REMARKS

Appl. No. 09/886,829
Atty. Docket No. 8595
Amdt. dated March 8, 2005
Reply to Office Action of December 8, 2004
Customer No. 27752

AMENDMENTS TO THE DRAWINGS

Fig. 9

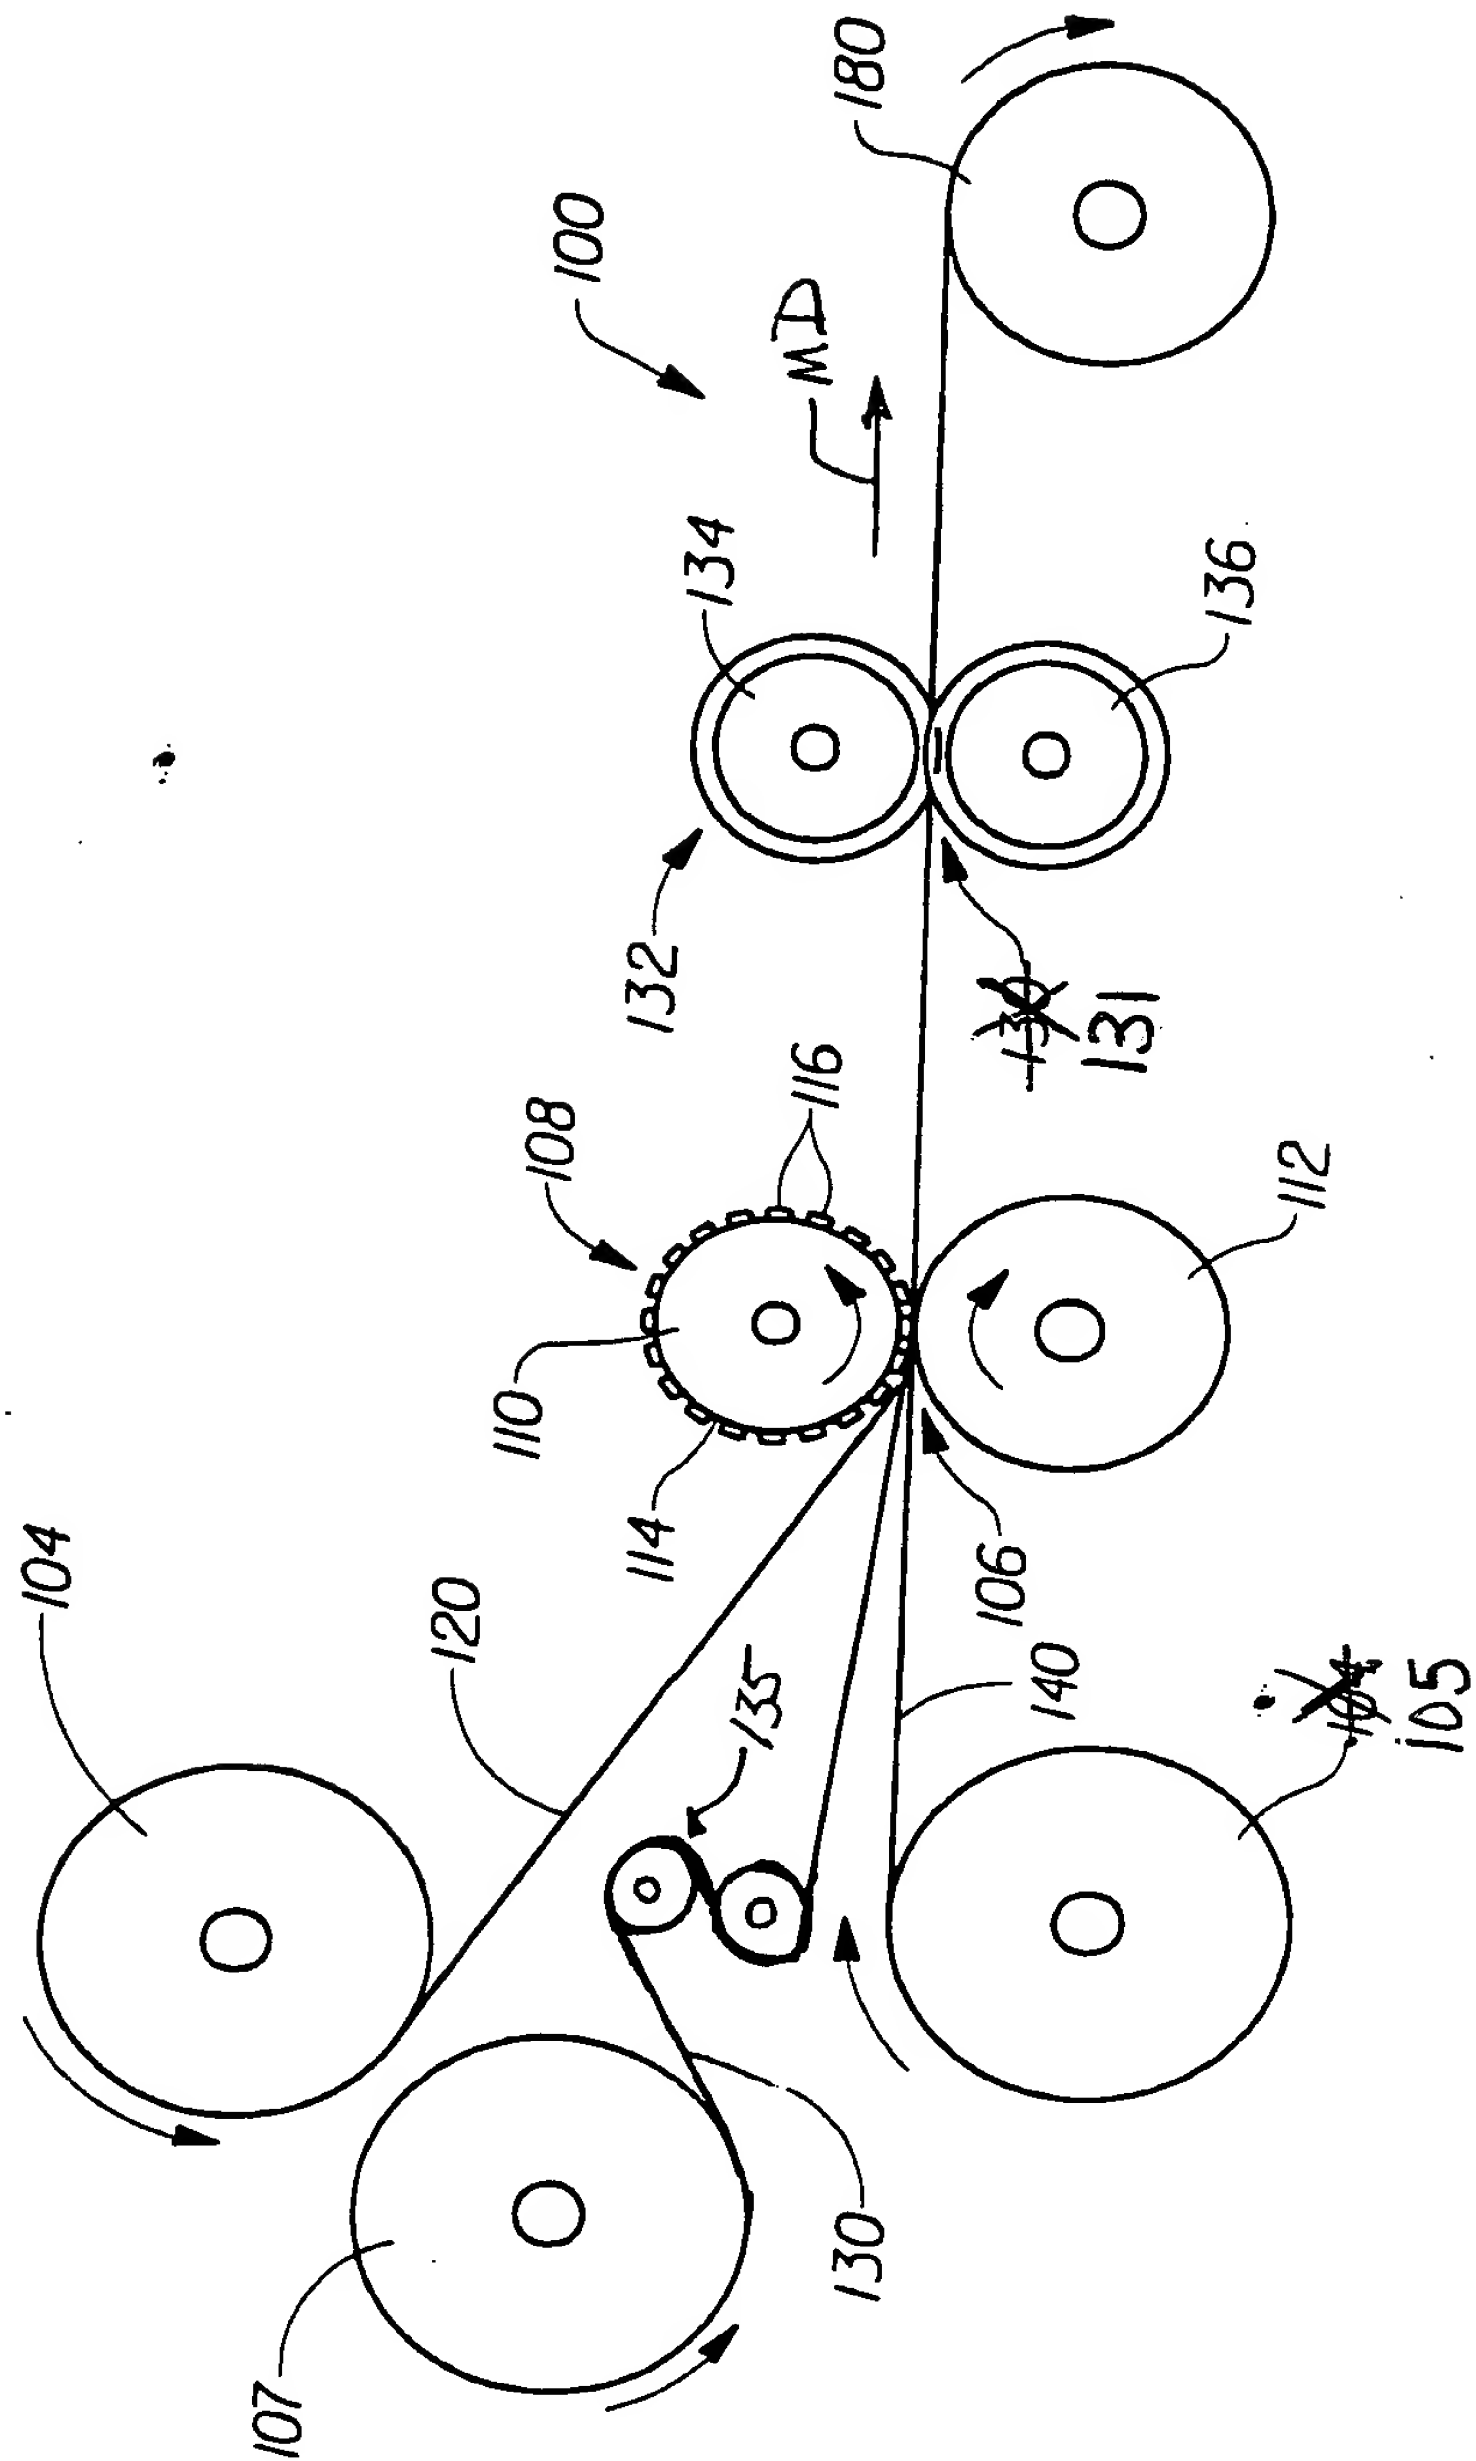
The attached sheets of drawings include amendments to Fig. 9. Character 105 is replacing character 104 for the second (lower) supply roll. The characters now correspond to the description in the specification. Character 131 is replacing character 130 which designates the nip corresponding to incremental stretching system 132. A formal replacement sheet with the corrected characters for Fig. 9 is attached.
